To: T10 Technical Committee
 From: Jerry Kachlic, Molex (Jerry.Kachlic@molex.com) and Rob Elliott, HP (elliott@hp.com)
 Date: 13 January 2005
 Subject: 05-023r1 SAS-1.1 Connector figures

This adds figures depicting each of the SAS connectors, kindly provided by Molex.

Figure 1 — SAS plug connector

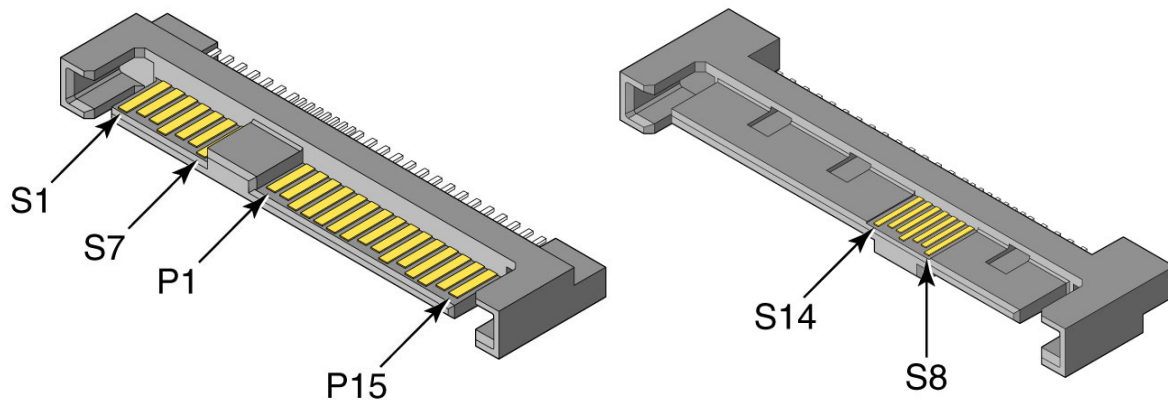
[Figure 1 shows the SAS plug connector.](#)

Figure 2 — Single-port SAS internal cable receptacle connector

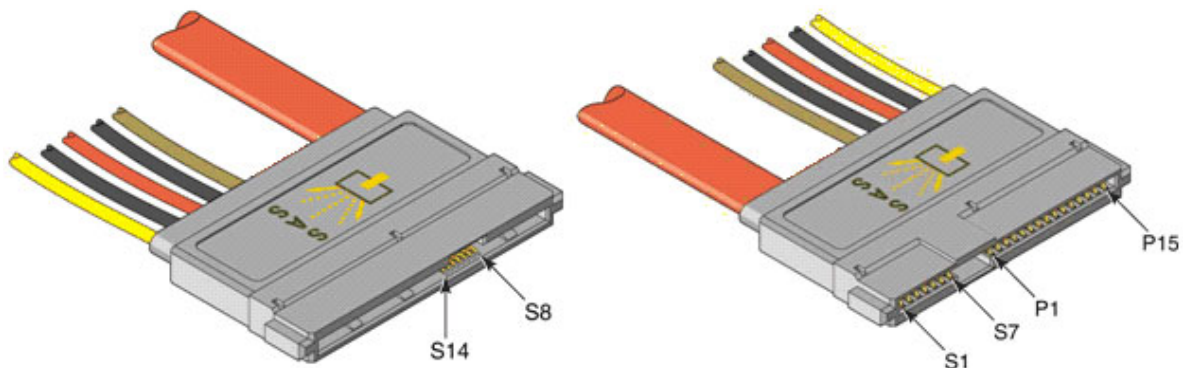
[Figure 2 shows the single-port version of the SAS internal cable receptacle connector.](#)

[Figure 3 — Dual-port SAS internal cable receptacle connector](#)

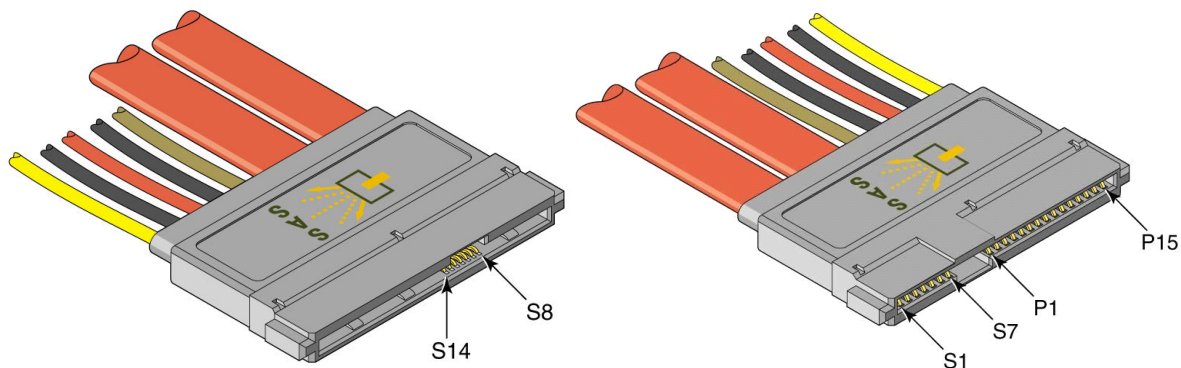
[Figure 3 shows the dual-port version of the SAS internal cable receptacle connector.](#)

[Figure 4 — SAS backplane receptacle connector](#)

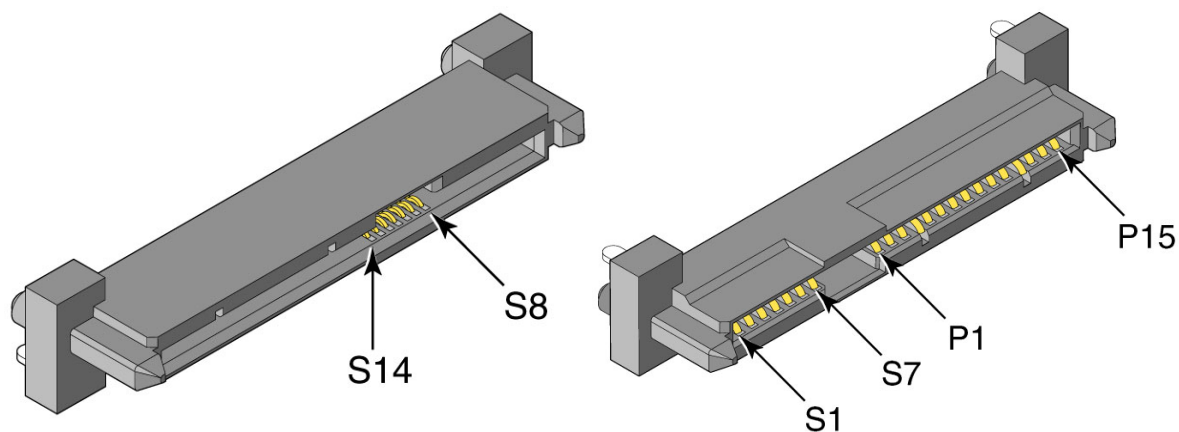
[Figure 4 shows the SAS backplane receptacle connector.](#)

[Figure 5 — SAS external cable plug connector](#)

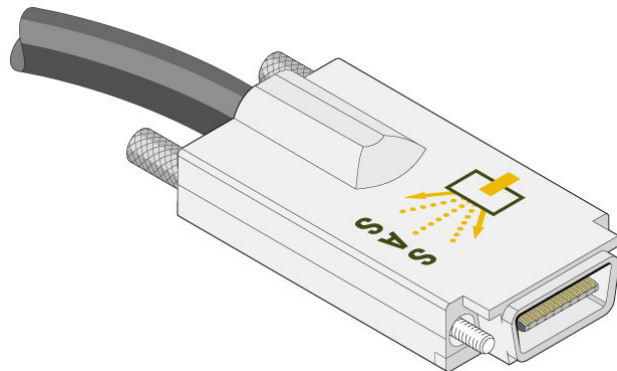
[Figure 5 shows the SAS external cable plug connector.](#)

[Figure 6 — SAS external receptacle connector](#)

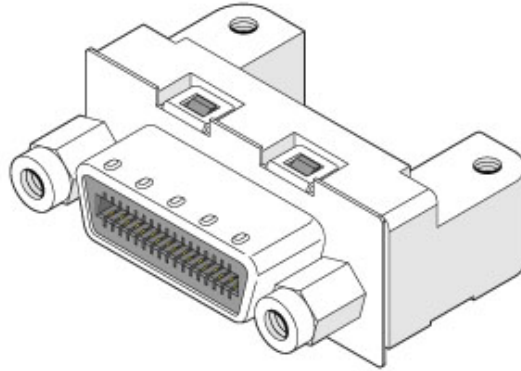
[Figure 6 shows the SAS external receptacle connector.](#)

[Figure 7 — SAS internal wide plug connector](#)

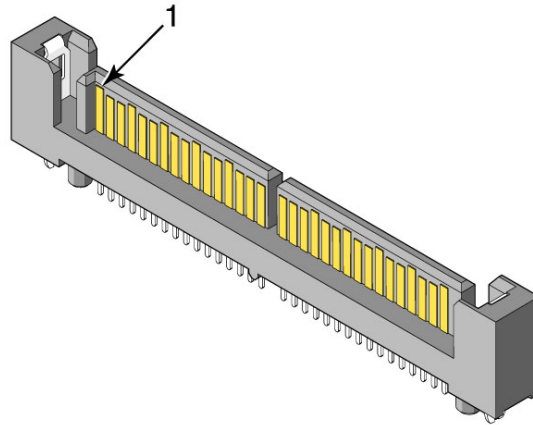
[Figure 7 shows the SAS internal wide plug connector.](#)

[Figure 8 — SAS internal wide cable receptacle connector](#)

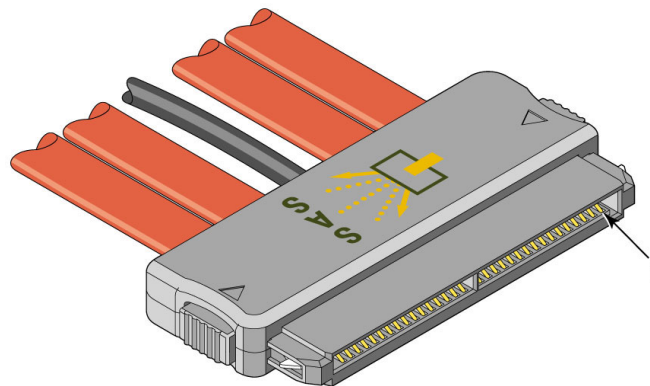
[Figure 8 shows the SAS internal wide cable receptacle connector.](#)
